Amendments to the Drawings

Appl. No. 10/788,833
Amdt. dated 03/28/2005
Reply to Office action of 11/28/2005

P804-1242E-US

Figure 5B

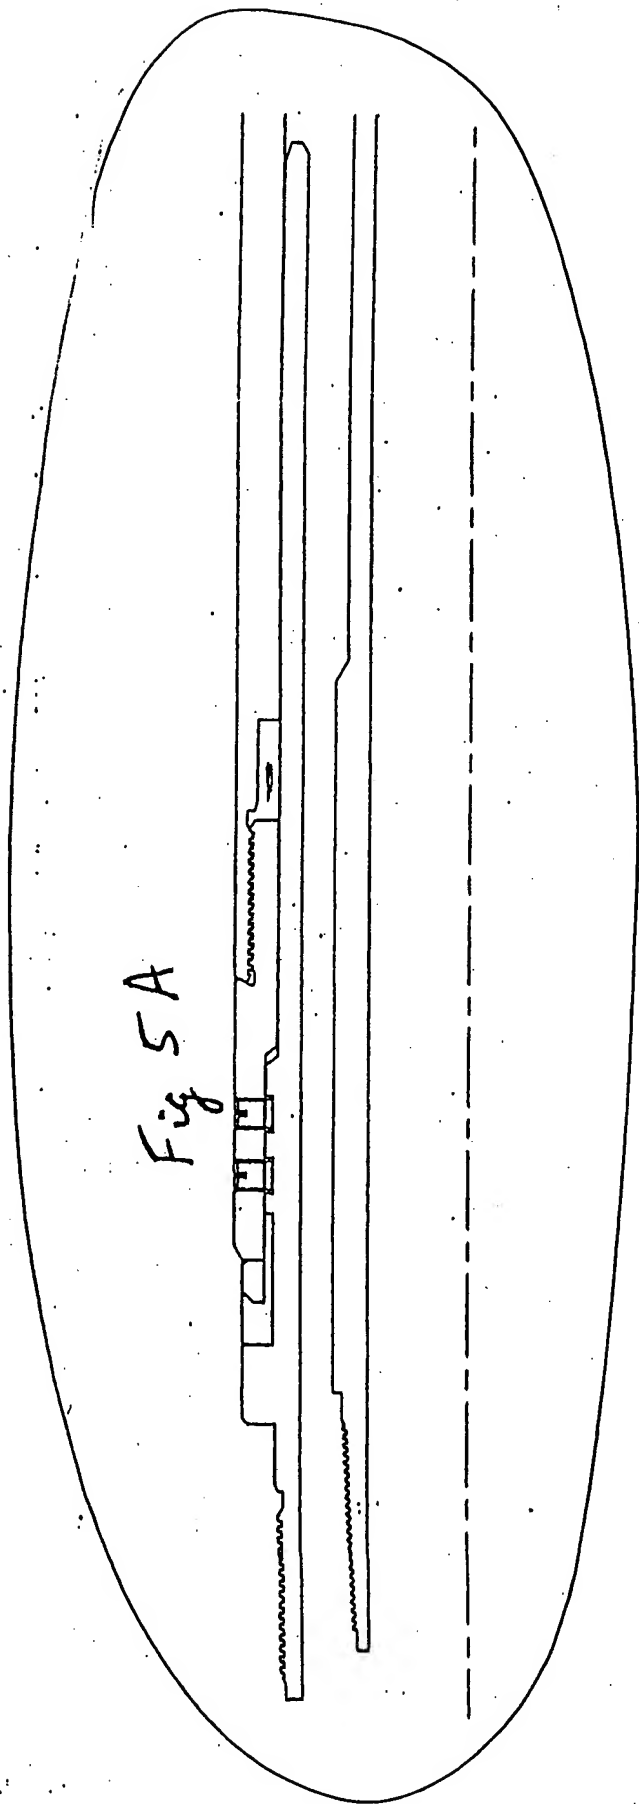
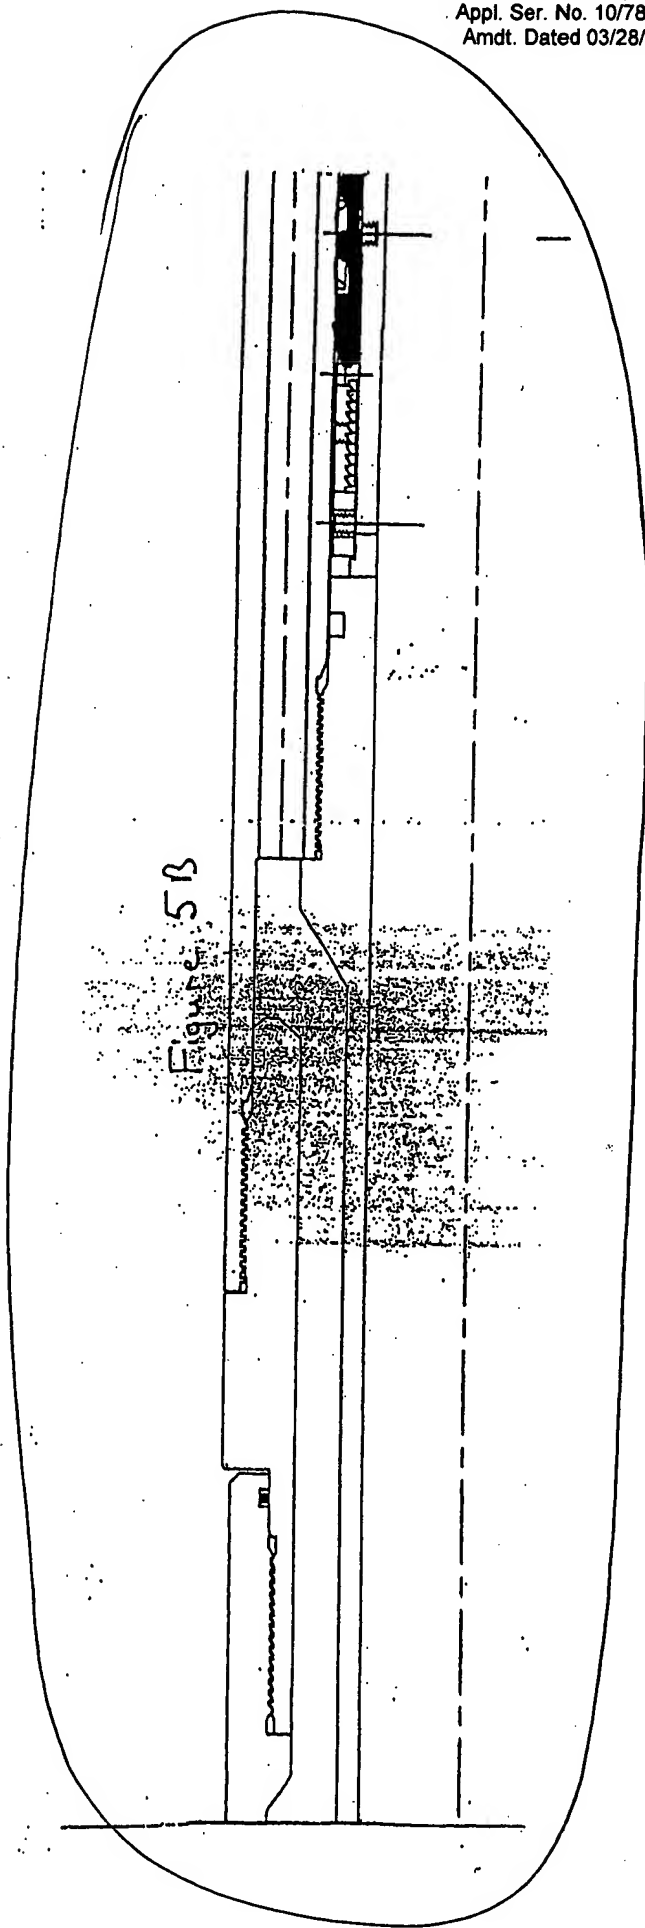
1. The drawing sheet containing Figures 5A and 6A has been amended by repositioning Figure 5A on the sheet and adding a centerline for Figure 5A.
2. The drawing sheet containing Figures 5B and 6B has been amended by repositioning Figure 5B on the sheet and adding a centerline for Figure 5B.
3. The drawing sheet containing Figures 5C and 6C has been amended by repositioning Figure 5C on the sheet and adding a centerline for Figure 5C.
4. The drawing sheet containing Figures 5D and 6D has been amended by repositioning Figure 5D on the sheet and adding a centerline for Figure 5D.
5. The drawing sheet containing Figures 5E and 6E has been amended by repositioning Figure 5E on the sheet and adding a centerline for Figure 5E.

1. The drawings are again objected to because in Figures 5A-5E and 6A-6E each corresponding "figure" is actually only one figure and should be labeled as such, i.e. Figures 5AA and 6A are the same figure and should be labeled as one figure. The examiner recognizes that applicant is attempting to compare the location of the different elements of the tool for two different tool positions, i.e. open and closed as described in the Brief Description of the Drawings, however, this comparison can be shown in only one figure (see 37 CFR 1.84). The actual figures themselves need not be changed but only labeled as a single figure and the Brief Description of the Drawings changed accordingly. Corrected drawing sheets in compliance with 37 CFR 1.121(d) are required in reply to the Office action to avoid abandonment of the application. Any amended replacement drawing sheet should include all of the figures appearing on the immediate prior version of the sheet, even if only one figure is being amended. The figure or figure number of an amended drawing should not be labeled as "amended." If a drawing figure is to be canceled, the appropriate figure must be removed from the replacement sheet, and where necessary, the remaining figures must be renumbered and appropriate changes made to the brief description of the several views of the drawings for consistency. Additional replacement sheets may be necessary to show the renumbering of the remaining figures. Each drawing sheet submitted after the filing date of an application must be labeled in the top margin as either "Replacement Sheet" or "New Sheet" pursuant to 37 CFR 1.121(d). If the changes are not accepted by the examiner, the applicant will be notified and informed of any required corrective action in the next Office action. The objection to the drawings will not be held in abeyance.

It is first noted that the Brief Description of the Drawings specifically indicates that Figures 5 and 6 show the same valve only Figure 5 shows the valve in the open position and Figure 6 shows the valve in the closed position. Depicting this difference is allowed in a single figure such as that shown in the figure labeled Figures 5 and 6, however, this figure must only be given one label as a figure can only have a single label (see 37 § CFR 1.84(u)). If applicant wishes the open and closed positions to remain separate figures then the figures must be amended to remove the centerline and place space between

Applicant has amended Figures 5A – 5E and 6A – 6E.

Because Figure 5 illustrates an embodiment of the invention in the opened condition and Figure 6 illustrates a closed condition, Applicant considers them to be structurally different. Therefore, Applicant has amended these Figures to present them with separate centerlines. The undersigned thanks the Examiner for the detailed explanation and guidance, and regrets any inconvenience his prior responses may have caused.
